REMARKS

U.S. Serial No.: 10/695,754

V. Chan et al.

FIGURE 1

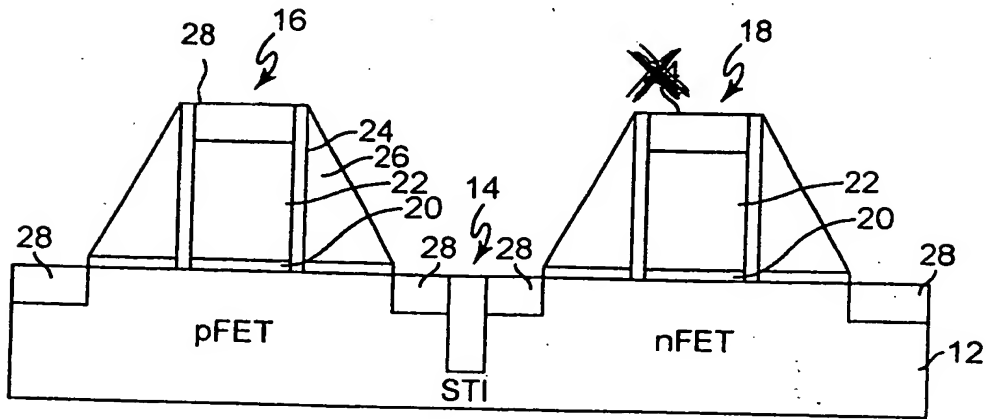
The specification has been amended in several locations to correct spelling and grammatical errors. An erroneous reference number has been deleted from Figure 1. No new matter has been introduced into the application.

Please approve the deletion of reference "24" in Figure 1, as shown in red on the marked-up copies (Annotated Marked-Up Drawings), and substitute therefore the attached Replacement sheet of Figure 1 which implements the change.
